**Planning & Development Division**  
*Planning & Economic Development Department*

File Number	PL 23-128	Contact	John Kelley, <a href="mailto:jkelley@duluthmn.gov">jkelley@duluthmn.gov</a>		
Type	MU-I Planning Review	Planning Commission Date		September 12, 2023	
Deadline for Action	Application Date	July 11, 2023	60 Days	September 9, 2023	
	Date Extension Letter Mailed	July 13, 2023	120 Days	November 8, 2023	
Location of Subject		2101 Trinity Road – Southwest corner of existing building			
Applicant	Lake Superior College	Contact	Mark Cardinal		
Agent	Architecture Advantage	Contact	Shane Nies		
Legal Description		010-2710-06620			
Site Visit Date		September 1, 2023	Sign Notice Date		August 29, 2023
Neighbor Letter Date		July 18, 2023	Number of Letters Sent		52

**Proposal**

Construction of 8,310 square foot building addition to house the Machine Tool and Welding programs as well as a loading and storage area. Additional site improvements include reconfiguring parking spaces and landscaping to facilitate the building addition.

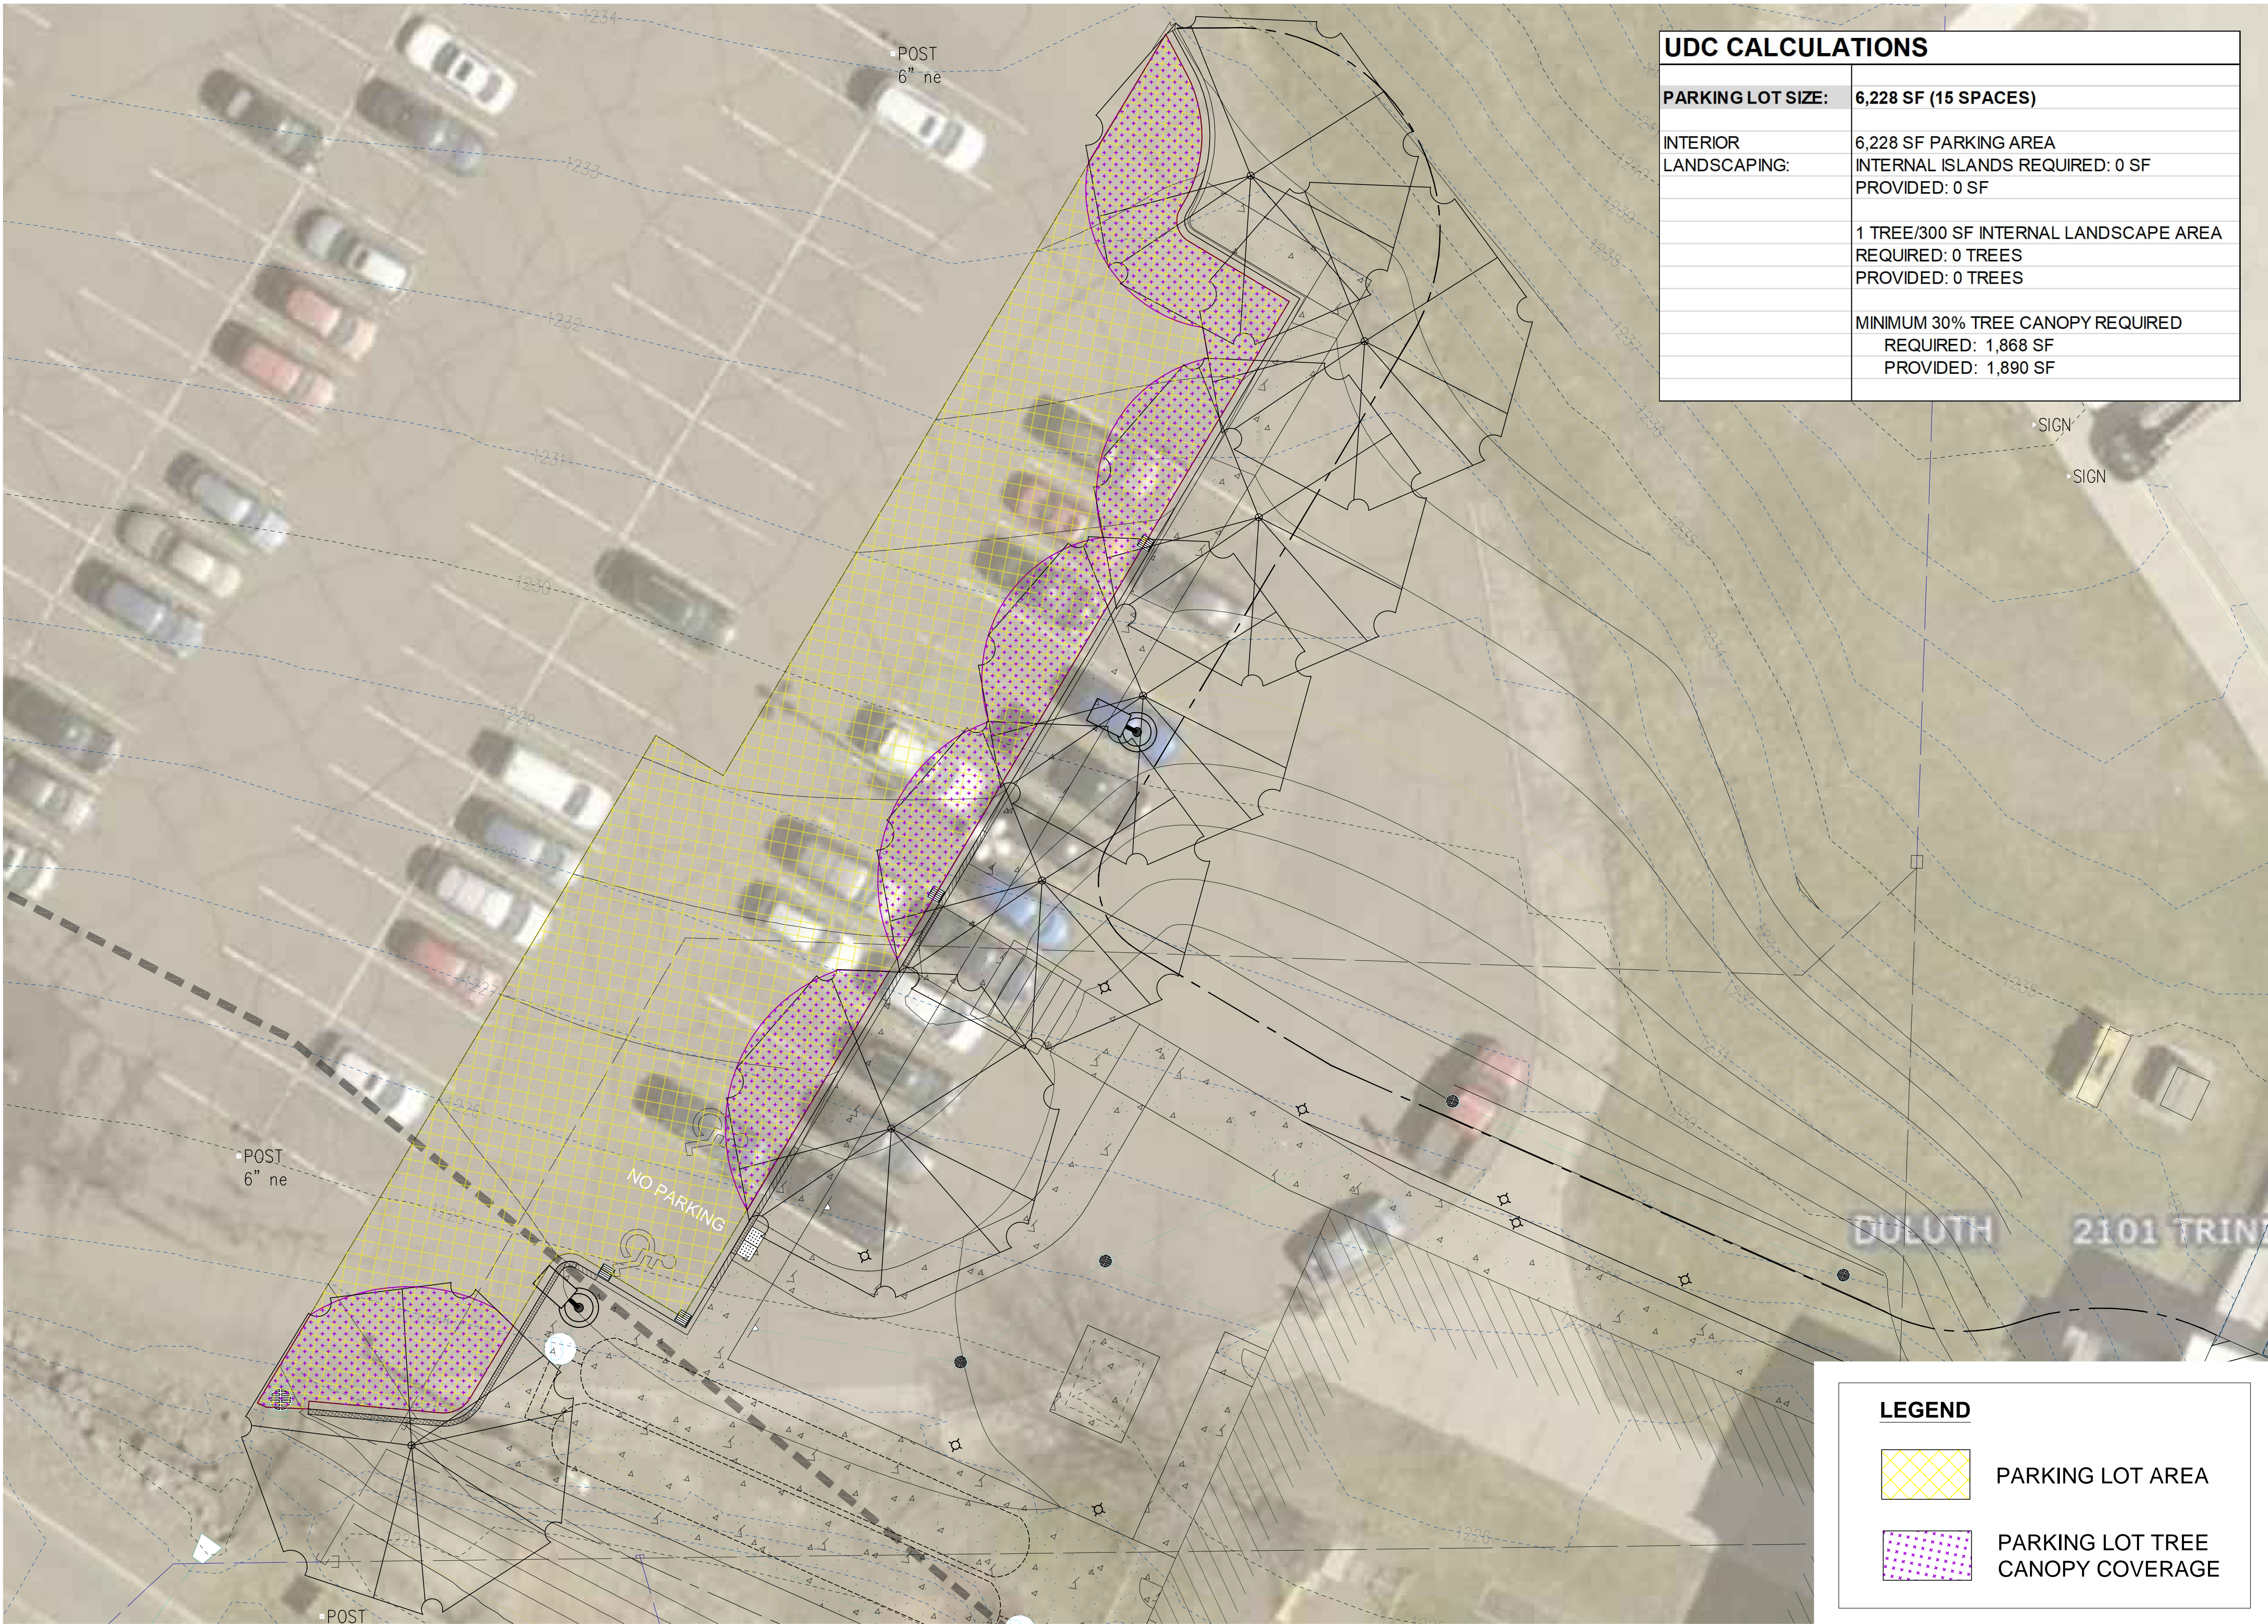
4. Proposed improvements do not trigger any UDC requirements related to landscaping, sustainability or building design standards. However, the new parking area with less than 25 parking spaces must provide the minimum tree canopy of 30 percent at maturity. The attached landscaping plan does include shrubs in the area between the building addition and the parking lot, and trees on either side of the building addition and along the front edge of the new parking spaces but did not include a canopy coverage calculation. The applicant did provide an updated tree planting plan meeting the 30 percent canopy coverage for the parking spaces. Staff is recommending the applicant provide an updated landscaping plan incorporating the 30 percent tree canopy coverage plan.

1. Applicant shall construct and maintain the project as identified in the attached exhibits.
2. Applicant shall submit a revised landscaping plan incorporating the 30 percent tree canopy coverage plan.
3. Applicant shall submit a lighting plan meeting the UDC lighting standards at the time of building permit submittal.
4. Any alterations to the approved plans that do not alter major elements of the plan may be approved by the Land Use Supervisor without further Planning Commission approval; however, no such administrative approval shall constitute a variance from the provisions of Chapter 50.
